**RESPONSE TO SUBMISSIONS**  
**SECTION 75W MODIFICATION (2)**

**DA 267-11-99**

**HODGSON QUARRIES AND PLANT PTY LTD**

3 December 2015

**Figure 1.6:** Extract from Figure 15 of the EIS which accompanied DA 267-11-99 showing Stage 1 and Stage 2 of the approved extraction and the location of the Cells of extraction for Stage 1.

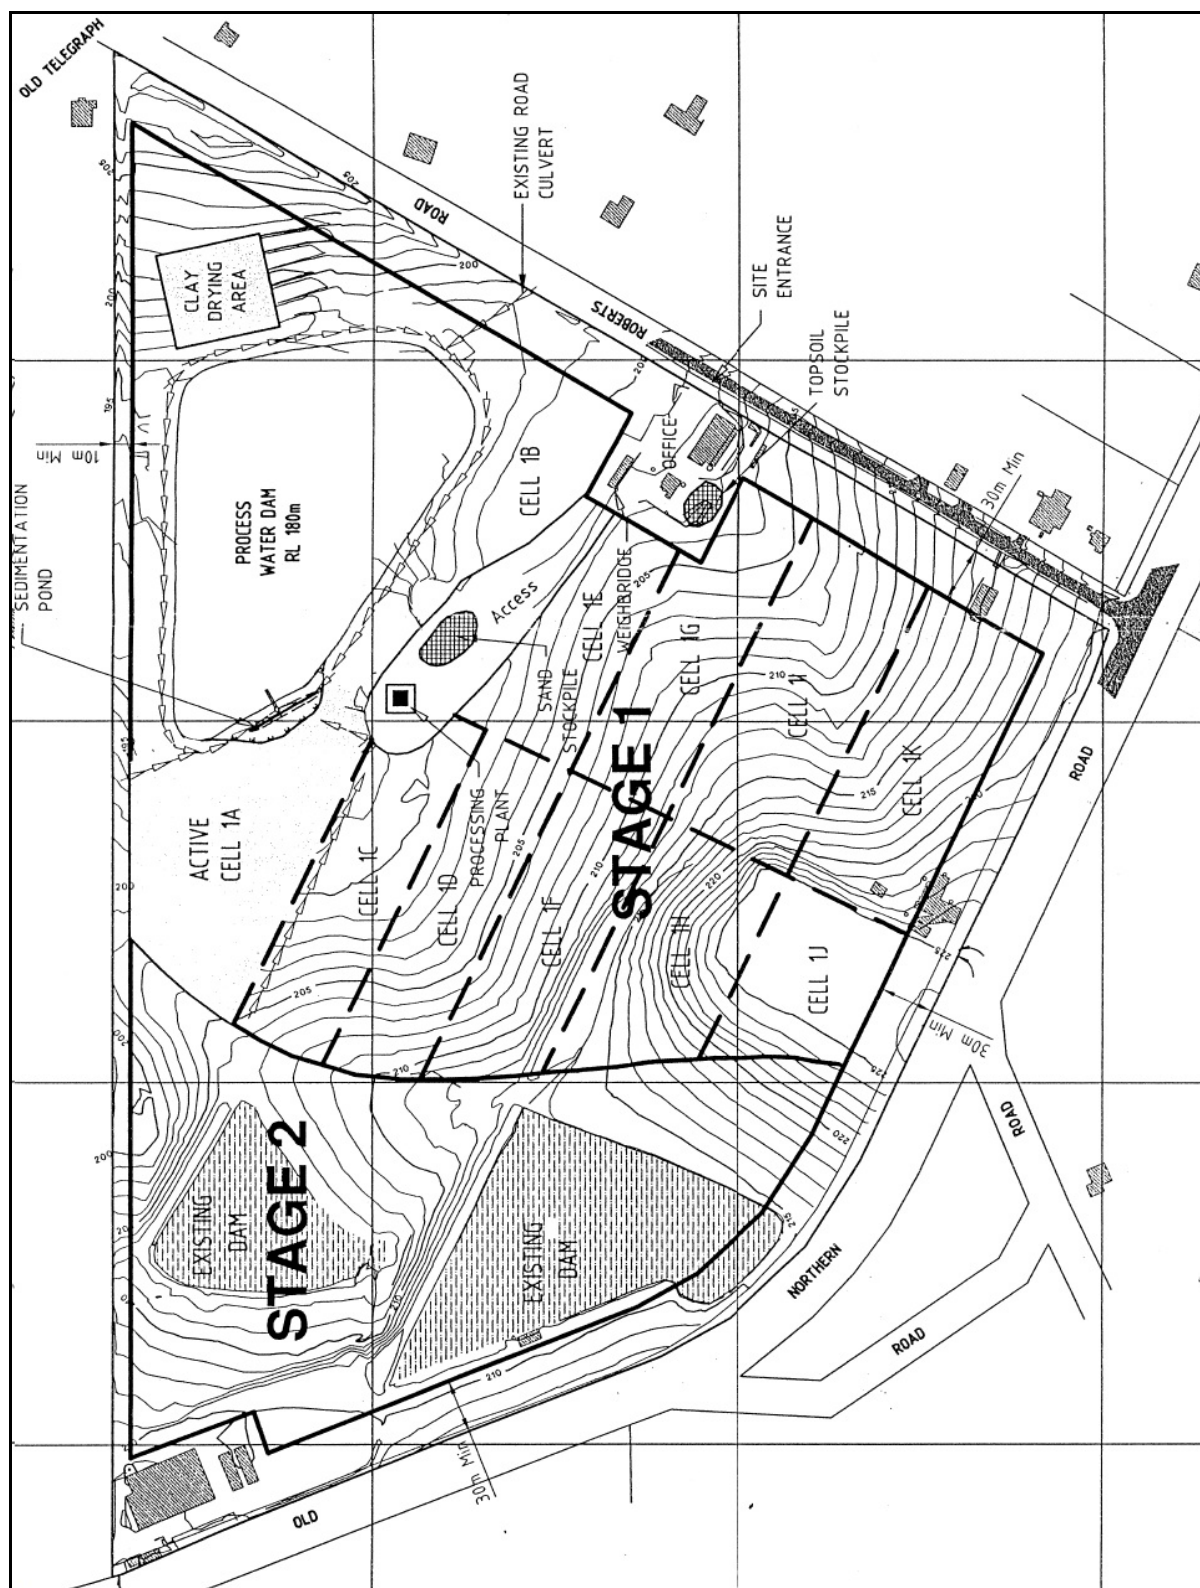
During the extraction process, it has been determined that the approved method of extraction using the cells shown in **Figure 1.6** is neither an economic nor practical way to achieve that extraction.

It is proposed to modify the approved sequence of extraction to reflect that which is now being undertaken on the Site such that the most efficient means of extracting the material on the Site is achieved.

**Figure 2.1:** Location of existing monitoring bore and proposed location of two (2) additional monitoring bores.

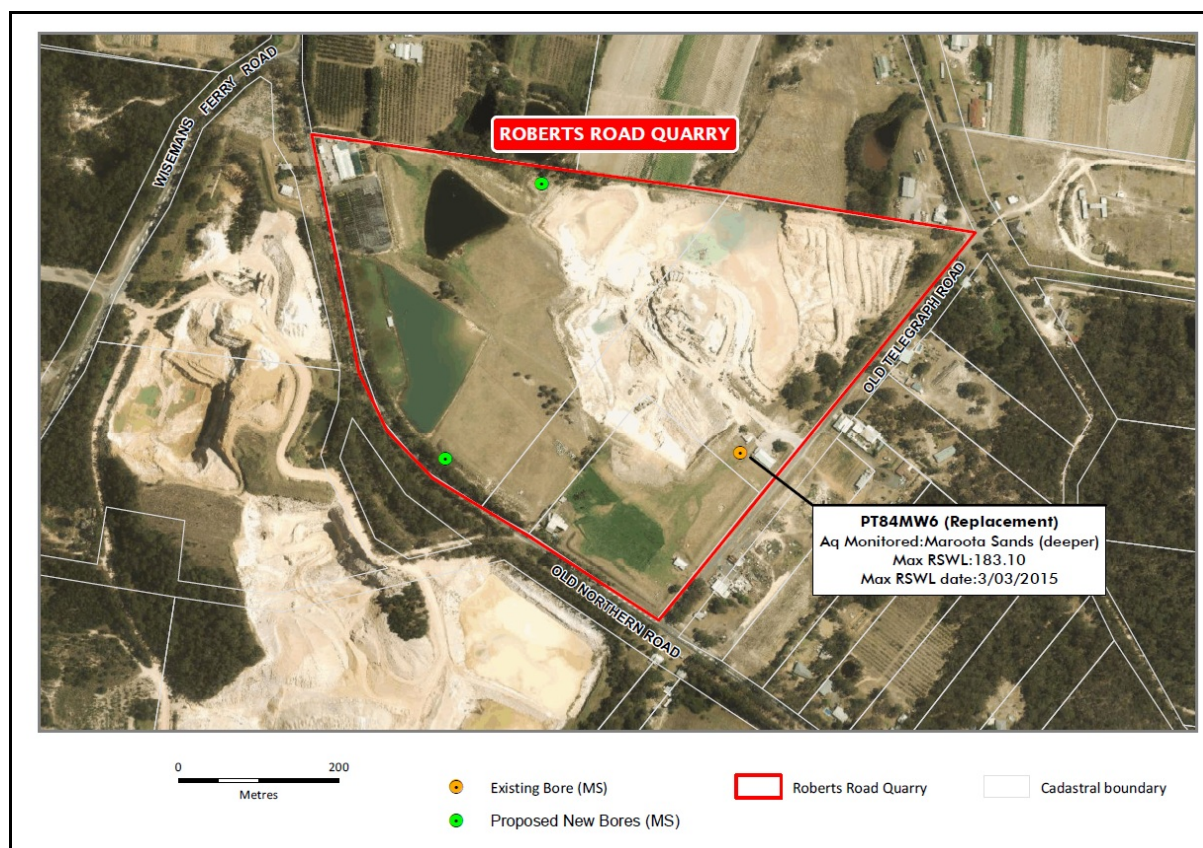
*The RSWMP notes the location of the bores and dams are shown on Figure 2 (Section 2.3.3). Figure 2 shows two monitoring bores (PT84MW1 and PT84MW5) occur on the site. Neither Table 1, nor Figure 2 refers to the monitoring bore (10BL605696) which was installed on 13/1/2015. The proponent needs to provide DPI Water with construction details of the bores on the site.*

It is agreed that additional groundwater monitoring bores are required to be installed on the site, however, the suggest six (6) bores is considered excessive for such a small site. It is recommended that an additional two (2) bores be located on the site as depicted in **Figure 2.1**.
